Placer County Office of Education
RFP for Lease-Leaseback Construction Services
*Office Building Tenant Improvements, Annex Building Alterations,
& Site Improvements @ Various Sites*

ADDENDUM NO. 5

Thursday, September 21, 2023

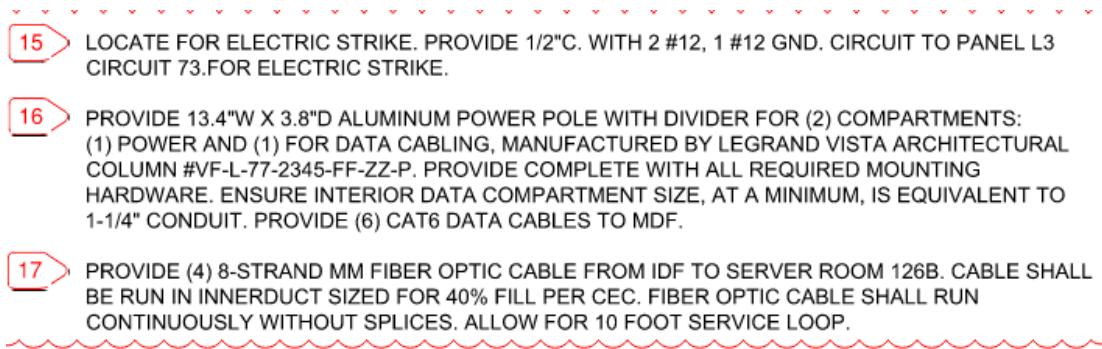
22. *Main Office: Drawing E3.05 has two note 16, one states (4) 8 strand fibers to open office areas 251 and 206 at a power pole. We believe this is an error that (4) 8 strand fibers are required, please confirm.*

Response: There is an error in the numbered notes. They should be numbered as shown below. Based on the numbering below, the power poles should have a note 16. IDF room 228 should have a numbered note 17 tag.

- 15 LOCATE FOR ELECTRIC STRIKE. PROVIDE 1/2"C. WITH 2 #12, 1 #12 GND. CIRCUIT TO PANEL L3 CIRCUIT 73.FOR ELECTRIC STRIKE.
- 16 PROVIDE 13.4"W X 3.8"D ALUMINUM POWER POLE WITH DIVIDER FOR (2) COMPARTMENTS: (1) POWER AND (1) FOR DATA CABLING, MANUFACTURED BY LEGRAND VISTA ARCHITECTURAL COLUMN #VF-L-77-2345-FF-ZZ-P. PROVIDE COMPLETE WITH ALL REQUIRED MOUNTING HARDWARE. ENSURE INTERIOR DATA COMPARTMENT SIZE, AT A MINIMUM, IS EQUIVALENT TO 1-1/4" CONDUIT. PROVIDE (6) CAT6 DATA CABLES TO MDF.
- 17 PROVIDE (4) 8-STRAND MM FIBER OPTIC CABLE FROM IDF TO SERVER ROOM 126B. CABLE SHALL BE RUN IN INNERDUCT SIZED FOR 40% FILL PER CEC. FIBER OPTIC CABLE SHALL RUN CONTINUOUSLY WITHOUT SPLICES. ALLOW FOR 10 FOOT SERVICE LOOP.
